# ANNOTATED SHEET SHOWING CHANGES

U.S. SERIAL NO.: 10/780,284

DLL CIRCUIT FOR STABILIZATION OF THE INITIAL  
TRANSIENT PHASE

FIG. 1

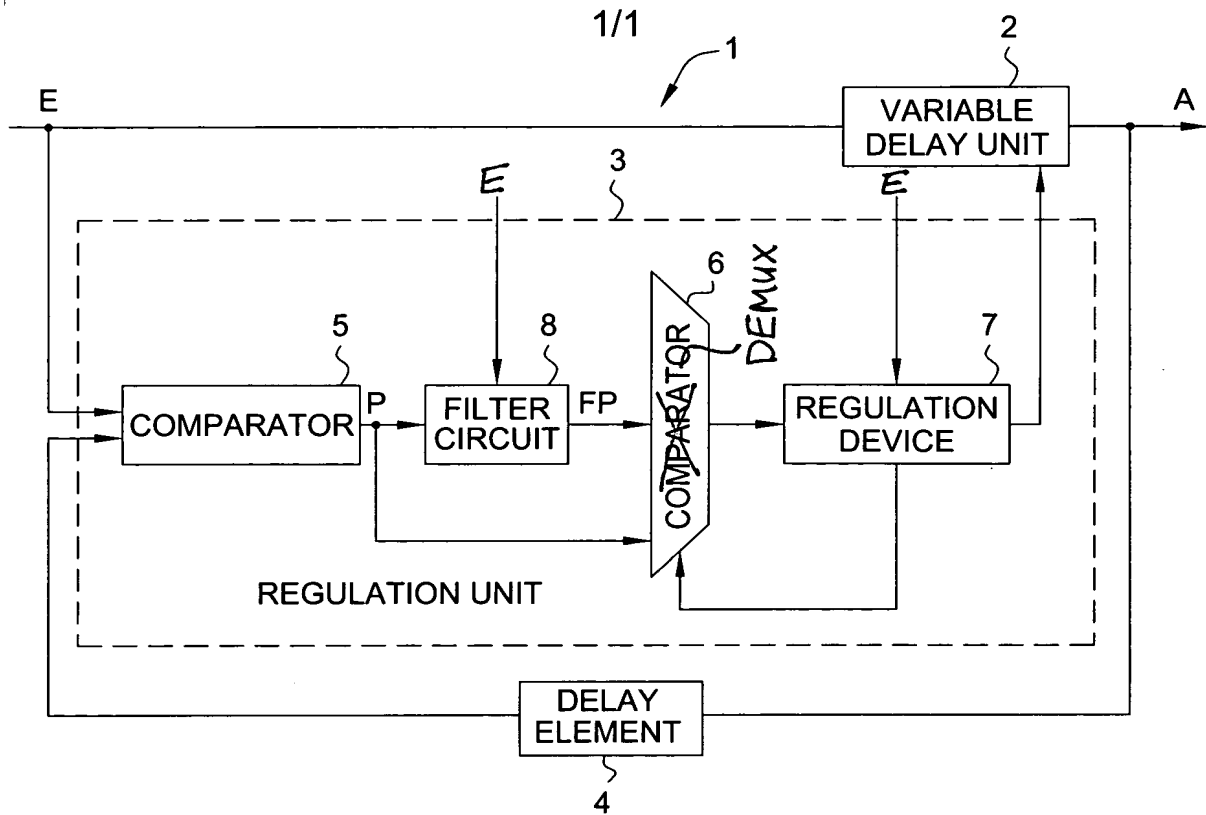
This amendment is filed to correct drawing informalities. The drawings were objected to because the signal lines being provided to filter circuit 8 and regulation device 7 were not labeled. Figure 1 has been amended to label the inputs to these signal lines and to correct the label for the demultiplexer ("DEMUX") 6. The drawing objection is believed to have been obviated. Withdrawal of the objection is respectfully requested.
